ADDENDUM NO. 2

**STOUT FIELD BUILDING 18
MILITARY INTELLIGENCE BATTALION CONVERSION
INDIANAPOLIS, INDIANA**

IFB NO: MDI-SAB-24-B-014

GEDA Architects

T401

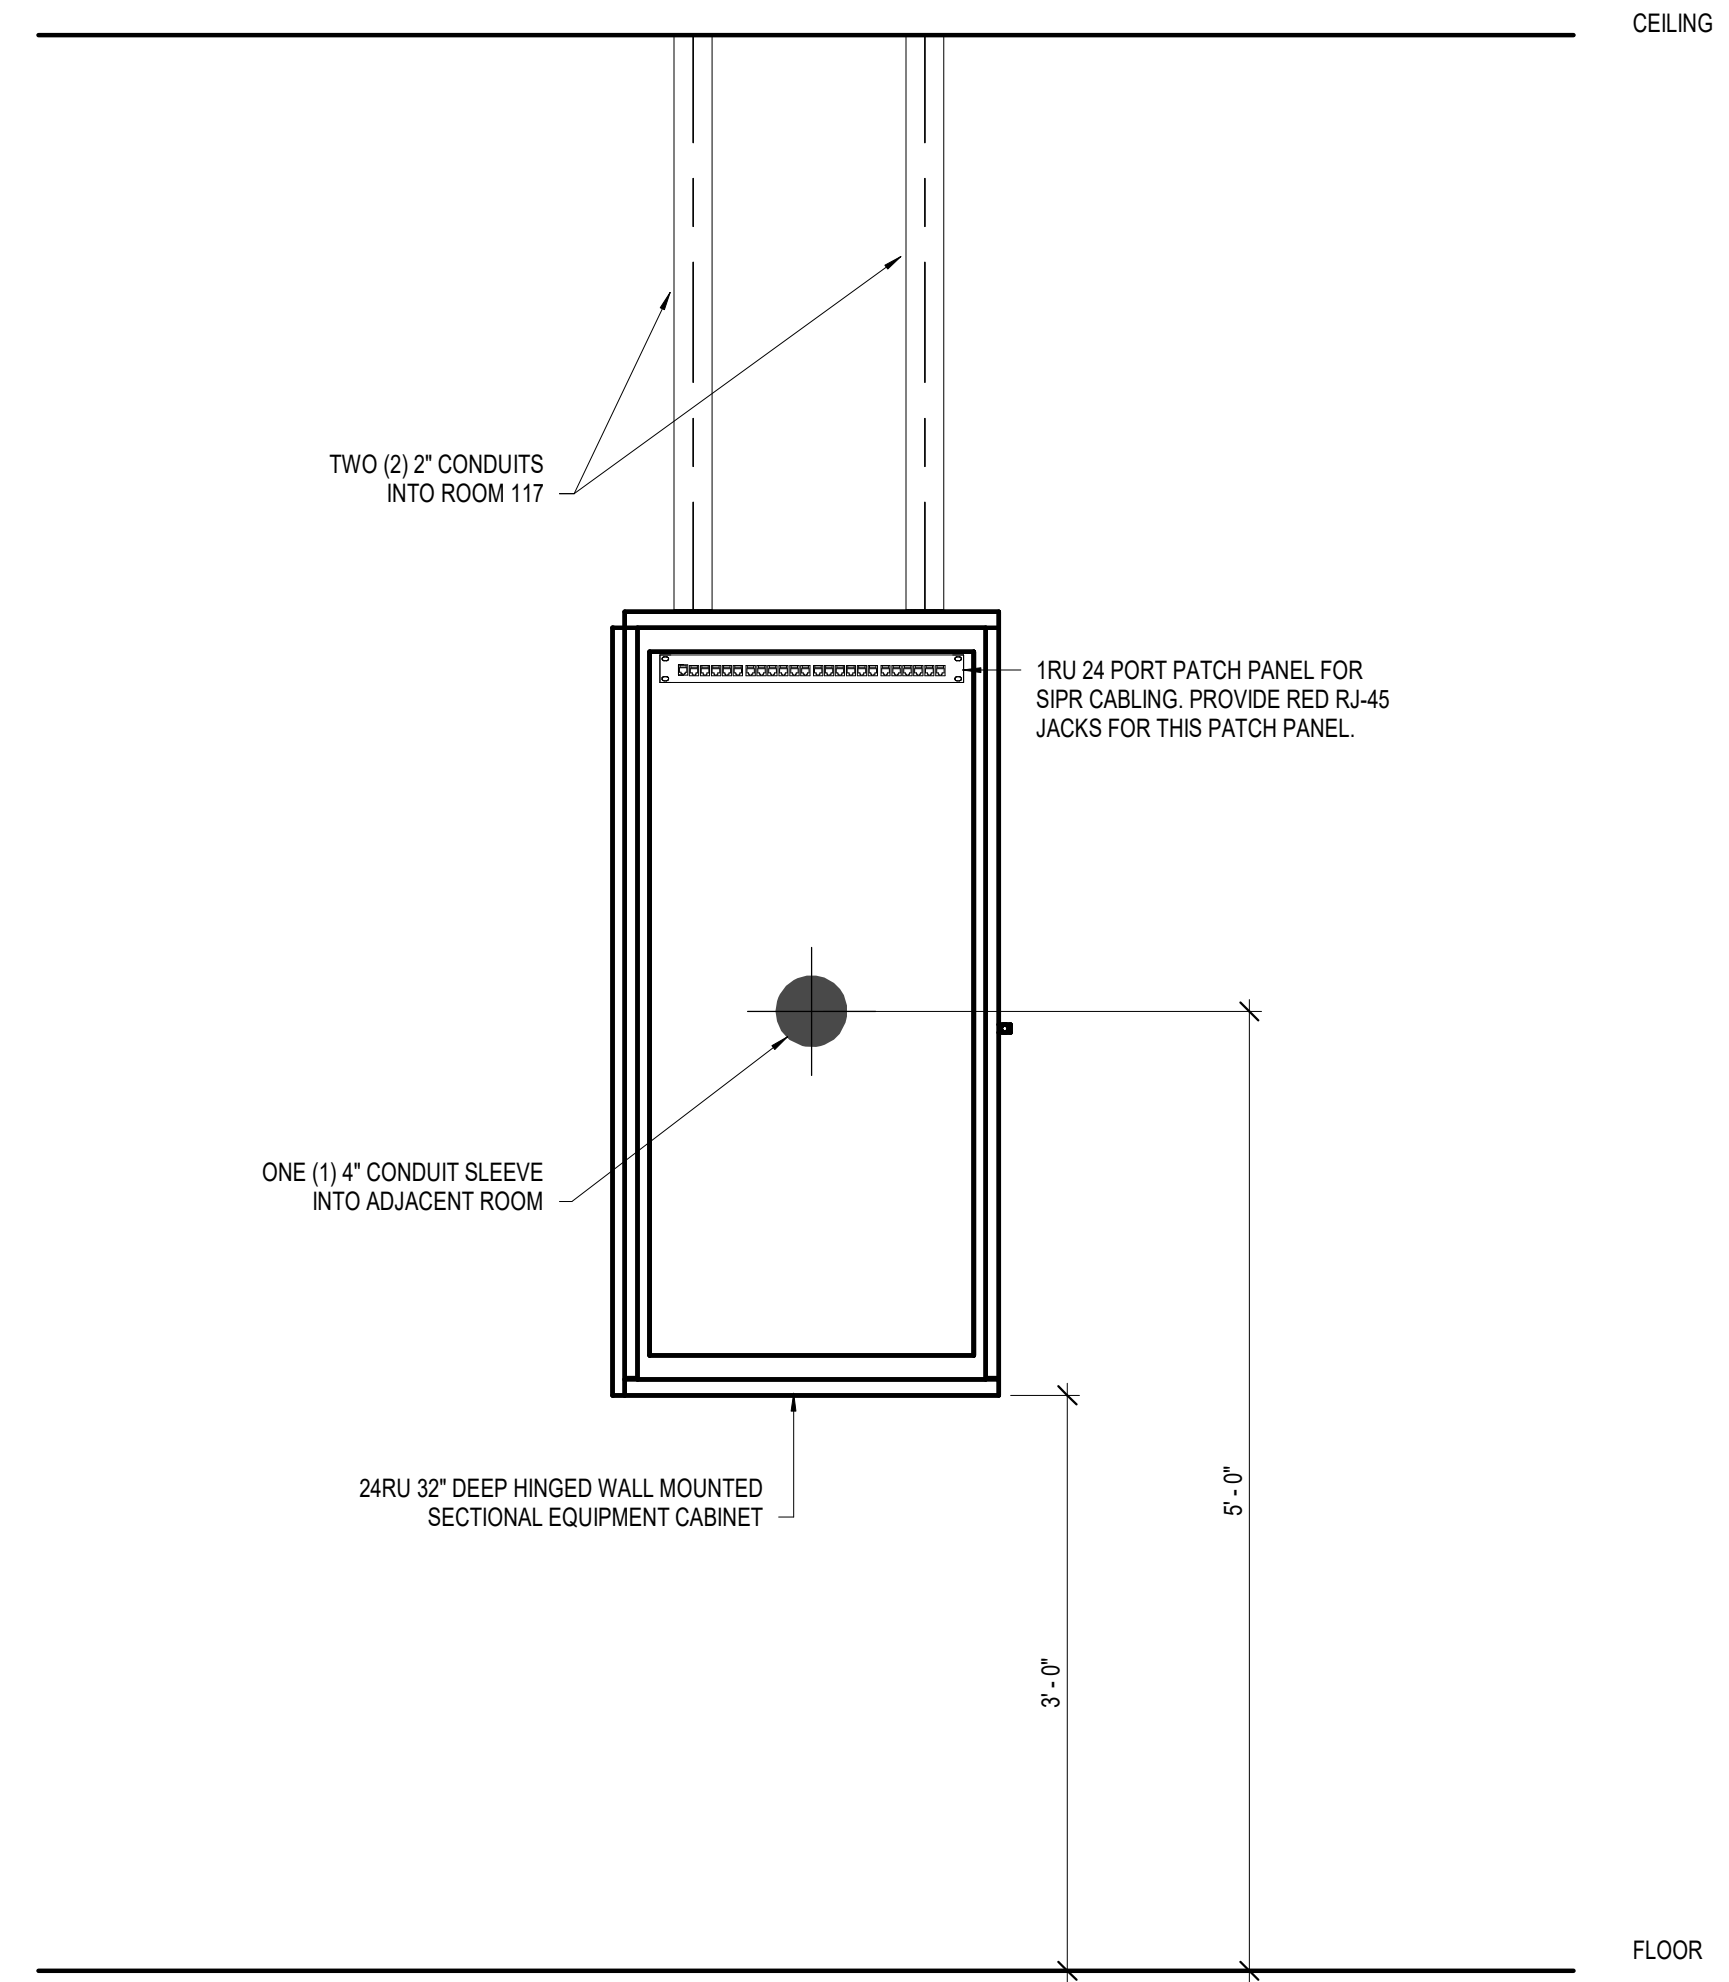
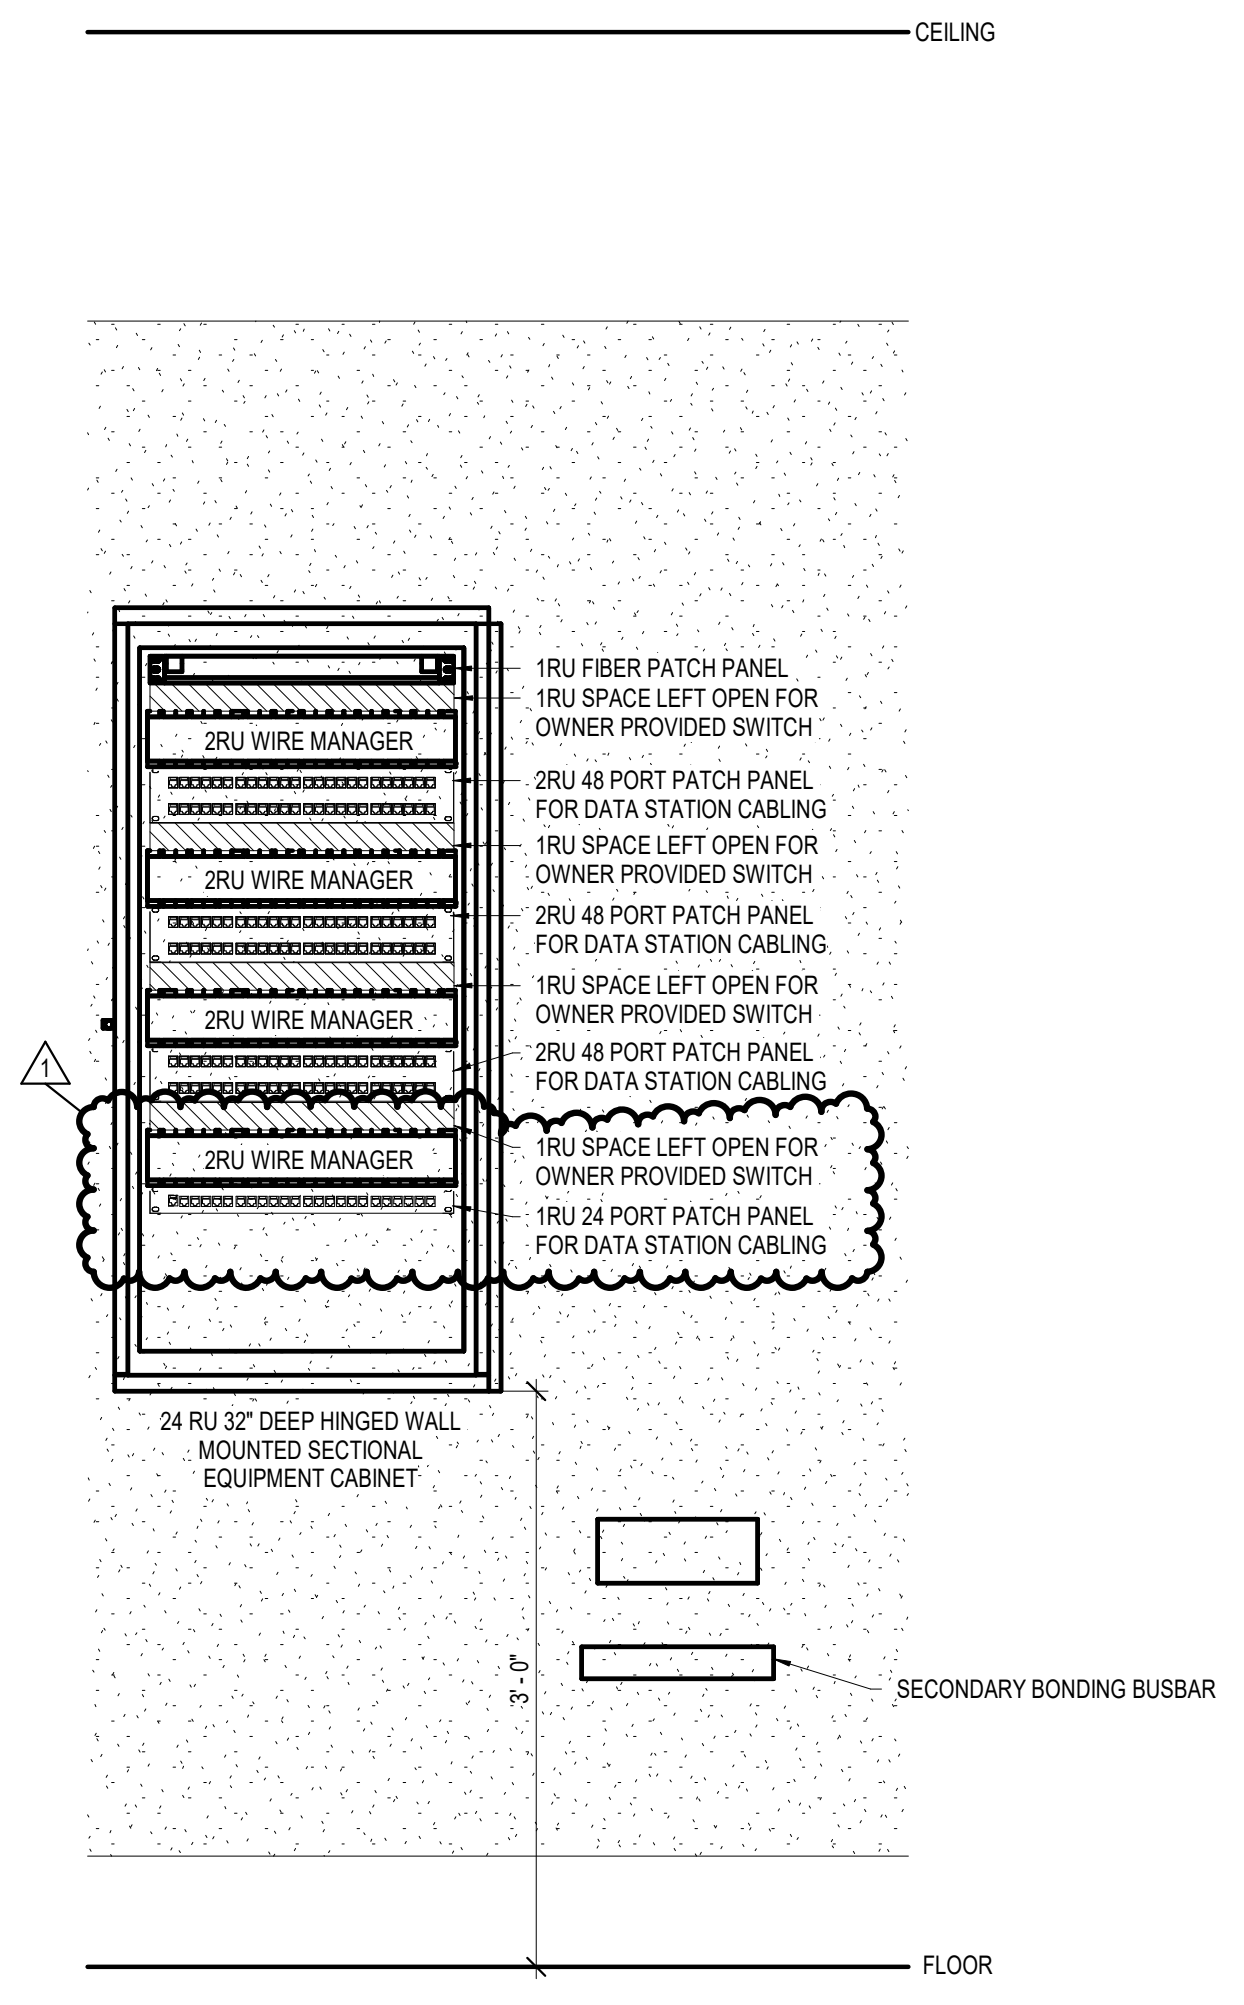
9. Sheet T401 – TECHNOLOGY ENLARGED PLANS
 - Added additional wire manager, patch panel, and space for switch to technology equipment cabinet.
10. Sheet M101 – FIRST FLOOR MECHANICAL PLAN

M101

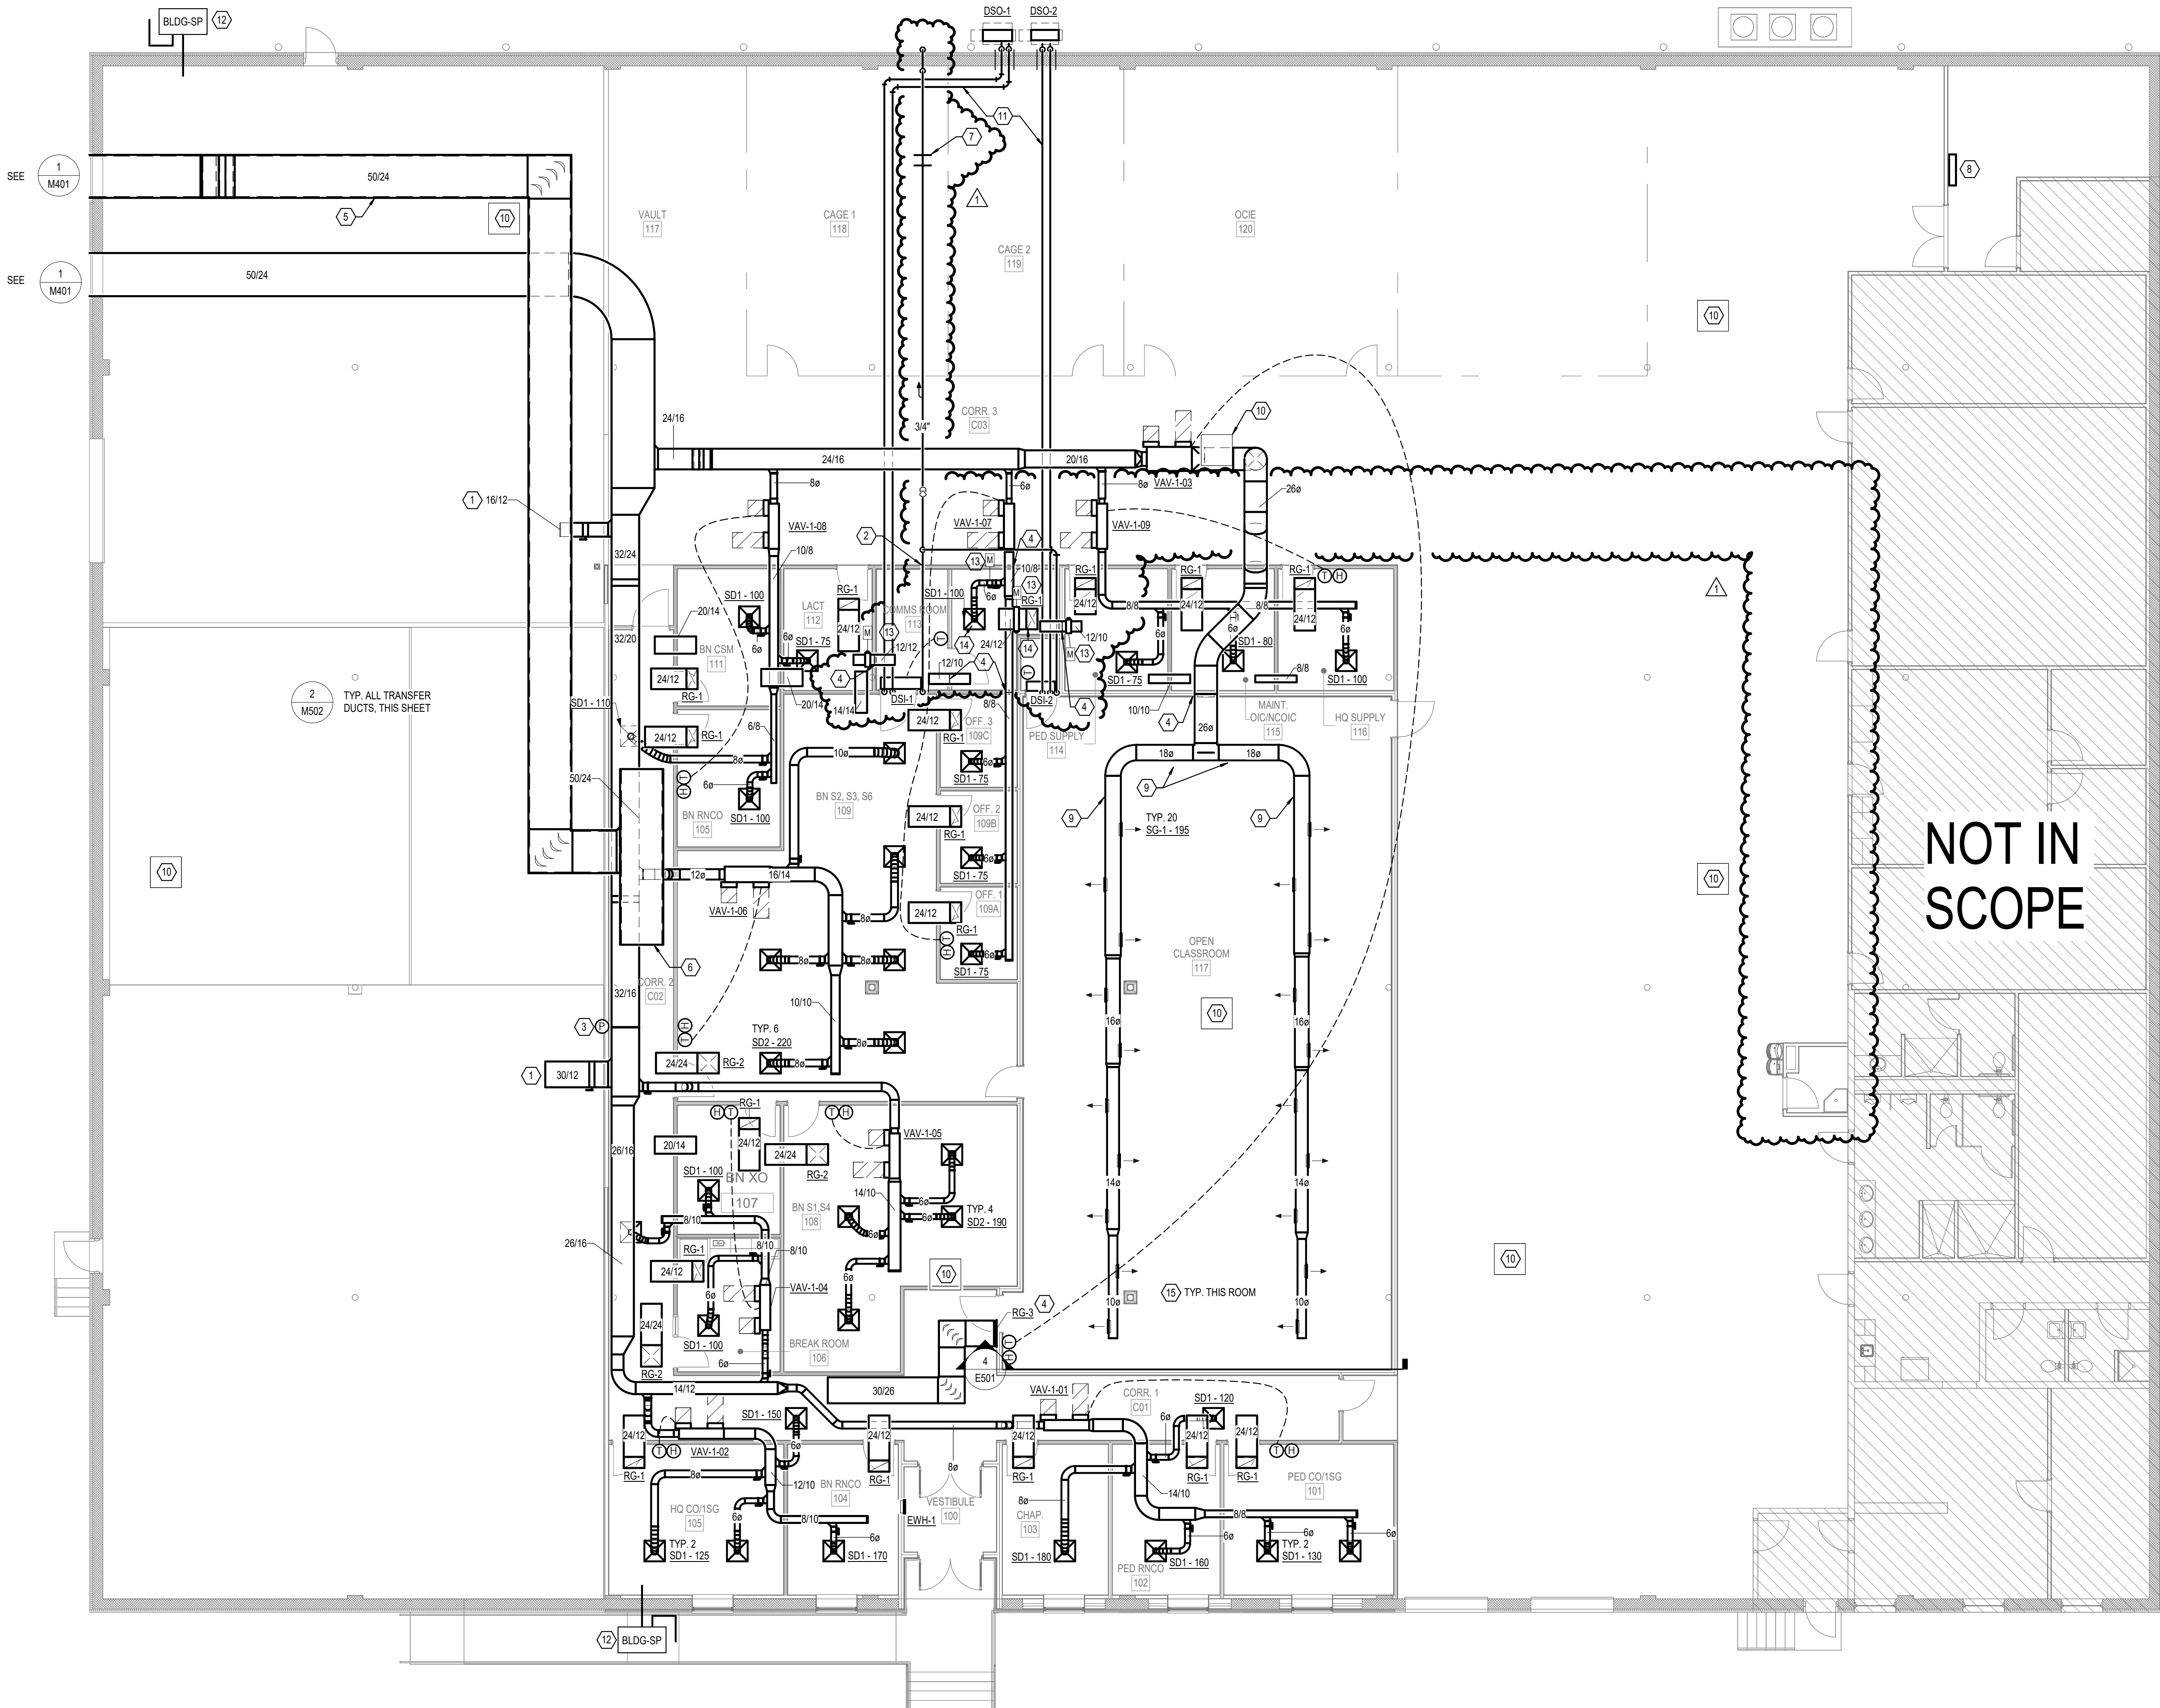
- Removed condensate drain line to existing mop sink. Routed condensate drain line to east exterior wall (keynotes 2 and 7).
 - Added ductwork security bars to ductwork serving and passing through COMMS RM – 113 (keynote 4).

- 1 CAP AND SEAL AIRTIGHT.
- 2 BASE BID. EXTEND PUMPED CONDENSATE TO EAST EXTERIOR WALL. AB1-1. EXCLUDE CONDENSATE PUMP AND ROUTE CONDENSATE TO NEW FLOOR DRAIN IN ASSOCIATED ROOM (TYP. 2).

- 3 PROVIDE WELDED SECURITY BARS AT DUCT OPENING INTO ROOM / DUCT THROUGH WALL - EQUAL TO GREENHECK XG-SGDB. INSTALL PER MANUFACTURER REQUIREMENTS.
- 4 INTERNALLY LINE ALL RETURN AIR DUCTWORK - REFER TO SPECIFICATIONS.
